MINOR CHANGE - A

☒ ORDERED BY ENGINEER UNDER TERMS OF SECTION 1-04.4 OF THE STANDARD SPECIFICATIONS ☐ CHANGE PROPOSED BY CONTRACTOR	CONTRACT NO.: CMP 1802 TO: Jeff Barcott, Owner
ENDORSED BY: Barcott Construction (Contractor Firm Name) Signature: [signature] Date: 4-29-2020 TITLE: Owner	Barcott Construction PO Box 366 Chehalis, WA 98532 COUNTY ROAD: Middle Fork Rd MP 7.07
	PROJECT TITLE: Middle Fork Rd. MP 7.07 Culvert Replacement Project (MF Newaukum R.) County Maintenance Project No. 1802

Minor Change (A) – Additional Anchored Large Woody Debris

DETAILS
MIDDLE FORK RD MP 7.07 (MIDDLE FORK NEWAUKUM RIVER) CULVERT REPLACEMENT
CMP 1802

MINOR CHANGE (A) - FIVE ADDITIONAL ANCHORED LARGE WOODY DEBRIS (HIGHLIGHTED DETAILS)

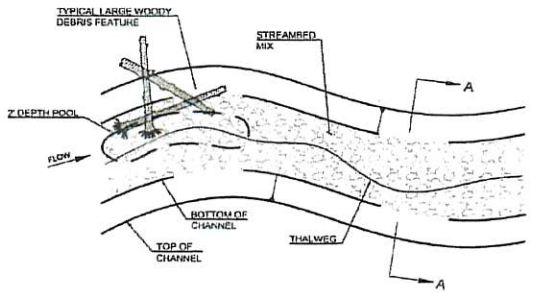
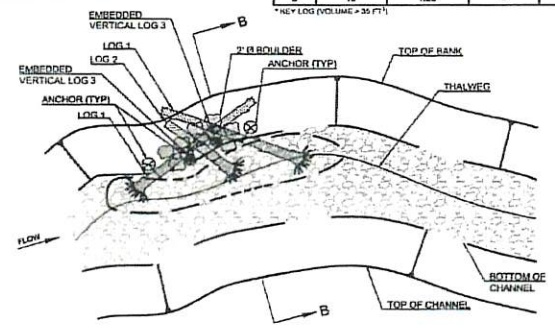
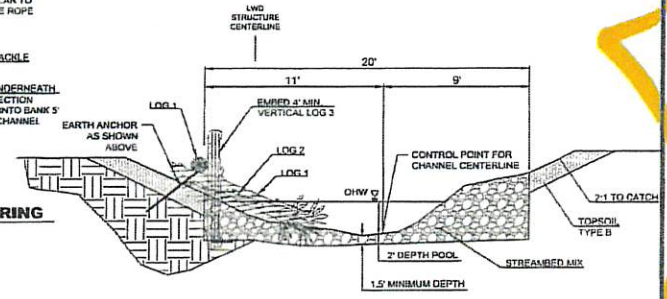
Minor Change (A) will include equipment re-mobilization, minor brush clearing, traffic control, labor, and material supply to construct five additional pieces of anchored large woody debris (LWD). The project plans originally incorporated six pieces of self-ballasting LWD which the Contractor installed under the direction of Lewis County's Consulting Engineer. High flows in October 2019 caused all LWD pieces to shift and dislodge from their original position. Existing LWD pieces are downstream of the culvert site and provide habitat in a limited capacity and will remain in their current locations. To provide bank stability immediately downstream of the culvert, five additional LWD pieces have been re-designed and approved through permitting agencies. The additional five LWD pieces will be installed and anchored using Manta Ray MR-2 anchors and rock ballast per details on page 2 of this Minor Change (A). This work is anticipated to be completed in one day during project's the in-water work window (June 15 – Sept. 30) and may constructed without the need for stream bypass (work area isolation as much as practical).
